# Sumter City-County Planning Commission

## MSP-25-55/HCPD-25-36 – 535 Brushwood Dr. (City)

**Request:** Request for Major Site Plan and Highway Corridor Protection District Design Review approval for 2 phases of development resulting in the establishment of a +/- 800 sq. ft. food/dining facility and associated site infrastructure.

Figure 4 – Phase 2 Site Plan

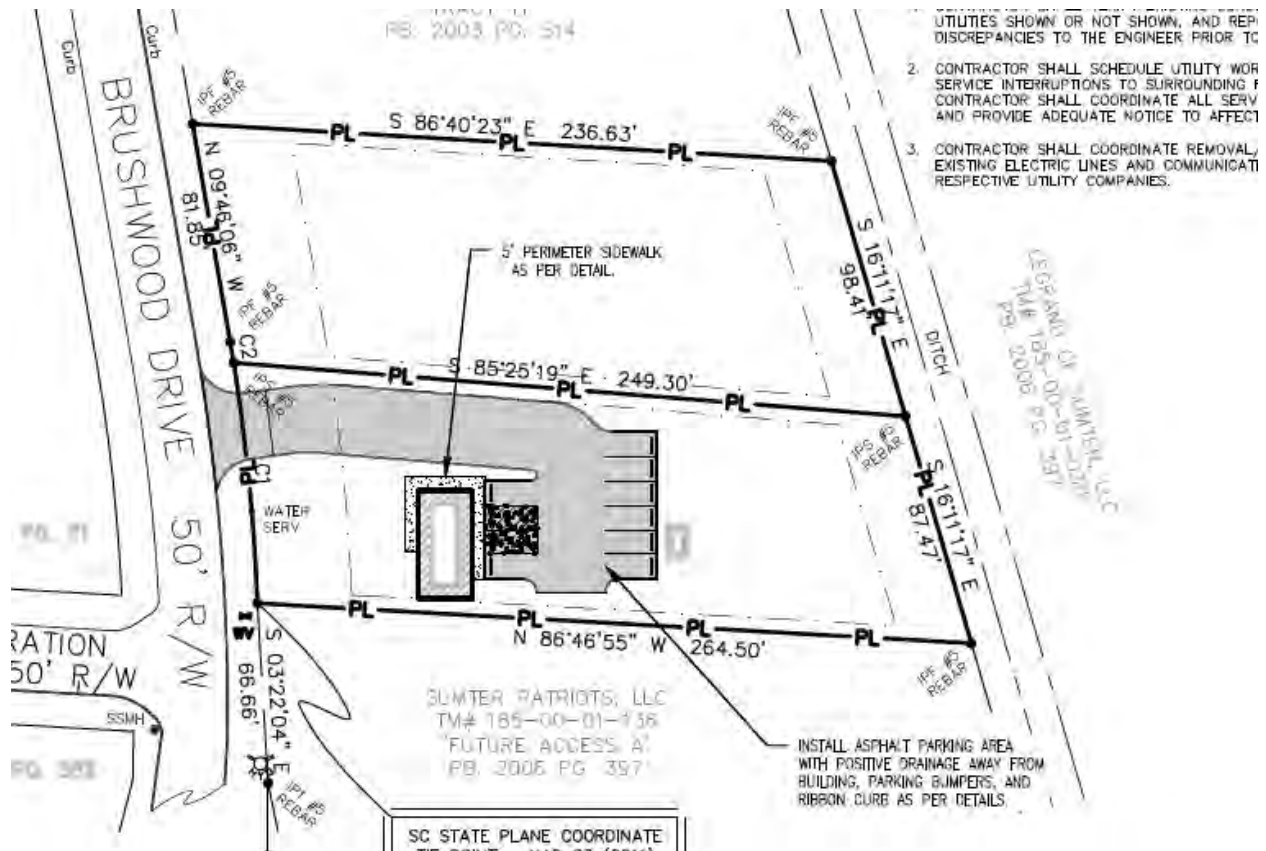
Based upon the criteria found in *Article 8, Exhibit 8-12: Off-street Parking Requirements for Non-Residential Land Uses* of the Ordinance, minimum off-street parking requirements for eating places (which the proposed use is classified as) requires 1.2 spaces per 100 sq. ft. of gross floor area (GFA). The proposal includes a bank with +/- 800 sq. ft. of floor area. 9 off-street parking spaces with at least 1 space being ADA accessible are required.

Submitted Phase 2 parking plans show the following:

- 9 standard 9x19 ft. parking stalls
- 1 designed ADA parking stalls
- 25 ft. aisle widths to support proposed 90-degree angled parking stalls;
- Landscaped edges of parking area with shade trees.

Figure 3 – Phase 1 Landscaping Plan

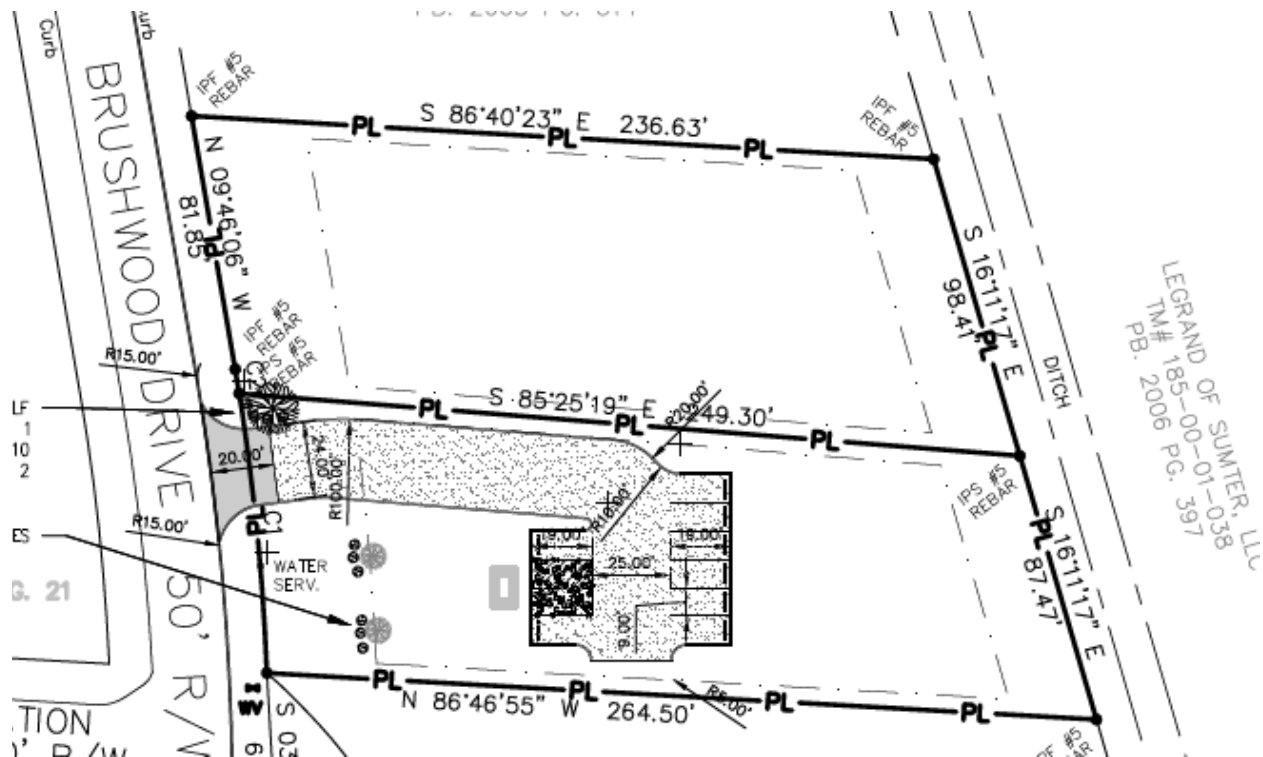
Street buffer landscaping consisting of 2 canopy trees, and 36 shrubs is required, based on the property's 90 ft. of street frontage. The applicant is proposing 1 canopy tree, 2 understory trees, and 6 shrubs. This under the required amount and the applicant has submitted an alternate landscaping waiver request pursuant to Article 9.d.6. of the Ordinance. Staff finds that this level of landscaping is acceptable for Phase 1 due the limited impacts of this proposal. However, a compliant amount of plantings shall be installed for Phase 2.

A 'Type A' landscape buffer (2 canopy trees, 2 understory trees, and 15 shrubs per 100 linear ft. within a 5 ft. wide buffer area) is required for the side property line. The development limits on the north side line is 165 linear feet, requiring 3 canopy trees, 3 understory trees, and 27 shrubs. The applicant is proposing no side landscaping for Phase 1. The applicant is proposing 2 canopy trees, 2 understory trees, and 12 shrubs for Phase 2. Staff finds that this level of landscaping is acceptable for Phase 1 due the limited impacts of this proposal. However, a compliant amount of plantings shall be installed for Phase 2.

Figure 4 – Phase 2 Landscaping Plan

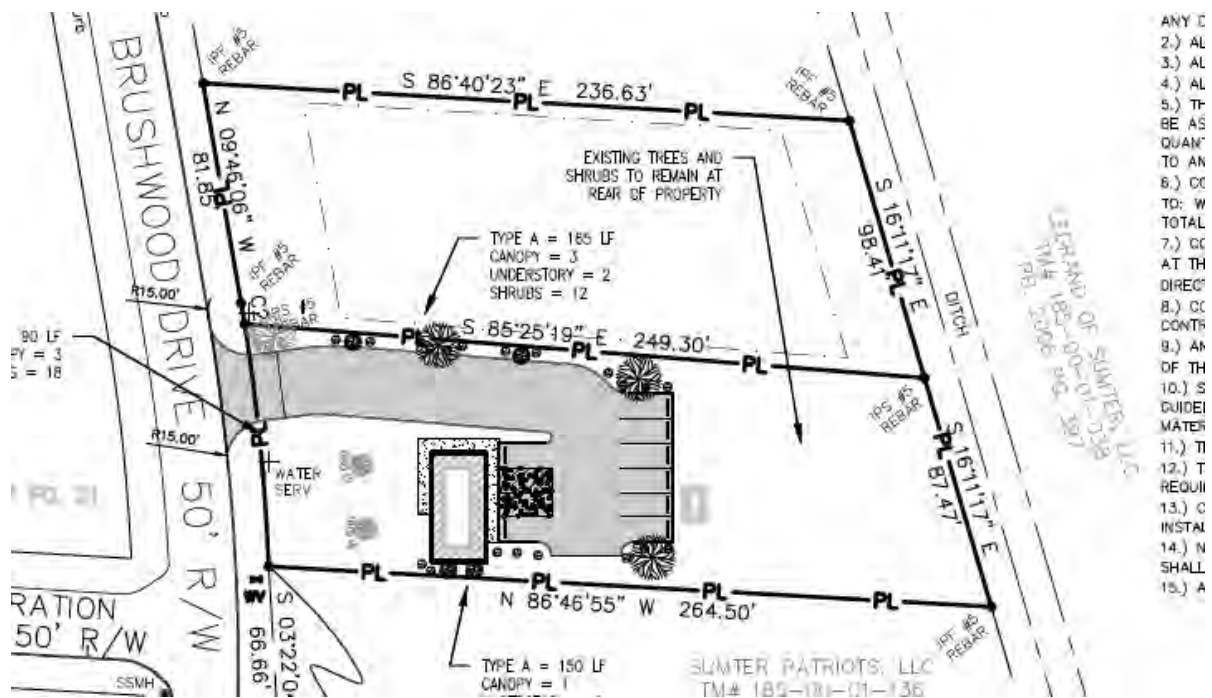
Type A landscape buffering (2 canopy trees, 2 understory trees, and 15 shrubs per 100 linear ft. within a 5 ft. wide buffer area) is required for the rear. The plan shows no rear landscaping. However, the rear of the site is wooded and the applicant intends preserve existing trees to serve as the required. Staff finds that this is an acceptable proposal.

The site is narrow and width. Due to the this, canopy trees that are part of the side buffers also serve as parking area shade trees. This proposal meets the intent of *Article 9* of the Ordinance.

1. Submit revised Phase 2 landscaping plans showing compliant amount of landscaping for street and side buffers. Revised plans shall include updated species lists with specific plantings proposed referenced on the planting schedule. Staff is not supportive landscape waiver requests for Phase 2 full build-out of the property.

Existing vegetation being retained within these buffers may be counted towards meeting this requirement. However, such existing vegetation must be detailed on the landscaping plan.
